June 18, 1997
6700-97-2121
6710-97-2267
6730-97-2188

Subject: Request for Additional Information, GPU Nuclear
Operational Quality Assurance Plan (Rev. 10)
Three Mile Island Nuclear Generating Station, Unit 1 (TMI 1)
Docket No. 50-289
Oyster Creek Nuclear Generating Station (OCNGS)
Docket No. 50-219

CURRENT ORGANIZATIONAL STRUCTURE

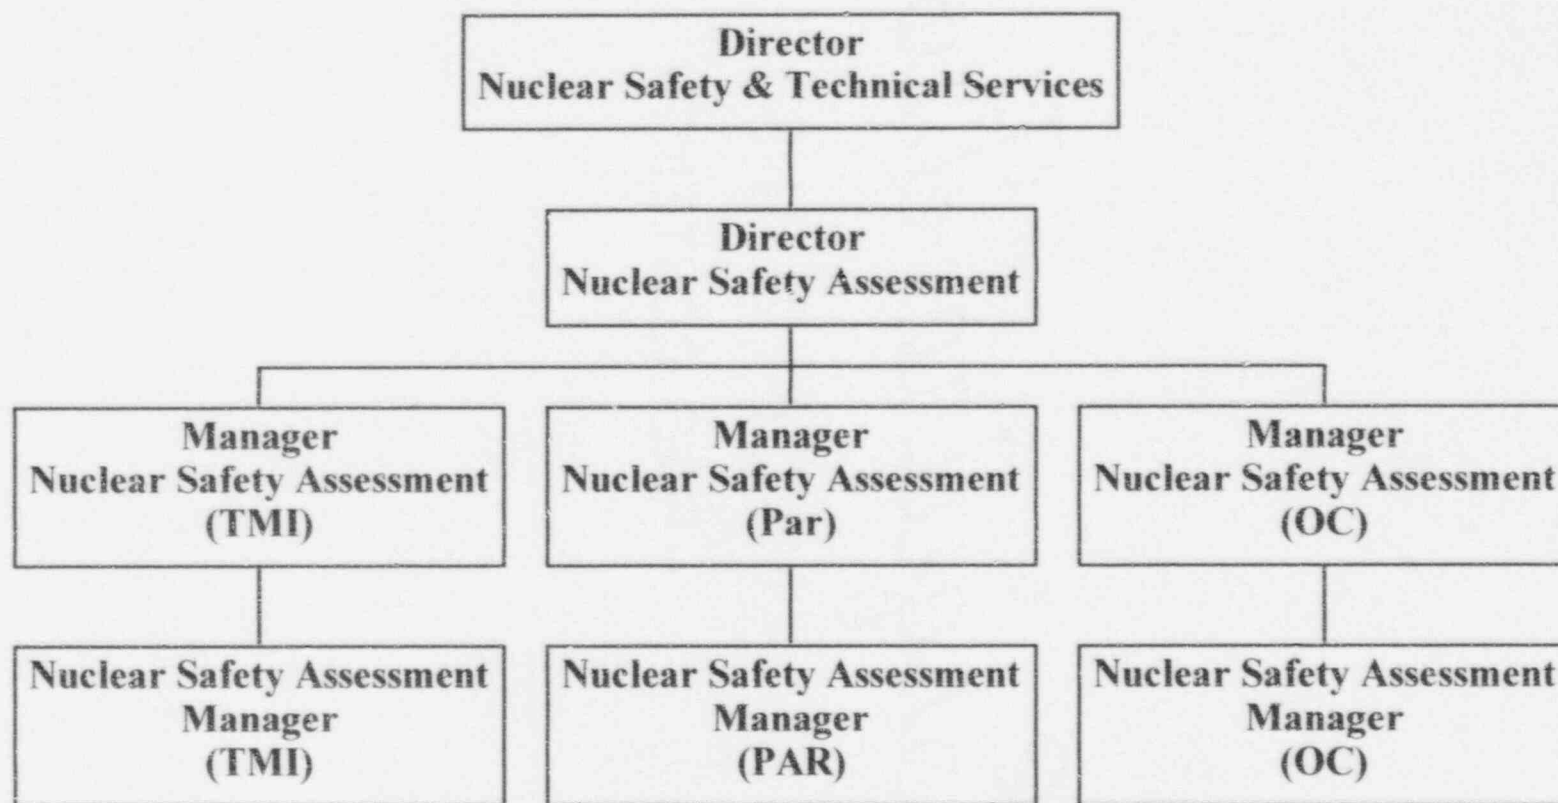
Question 2 of the RAI requests organization charts of the proposed organizational structure and the current structure. Attachment 1 is a depiction of the proposed organization and Attachment 2 portrays the organizational units as they currently exist.
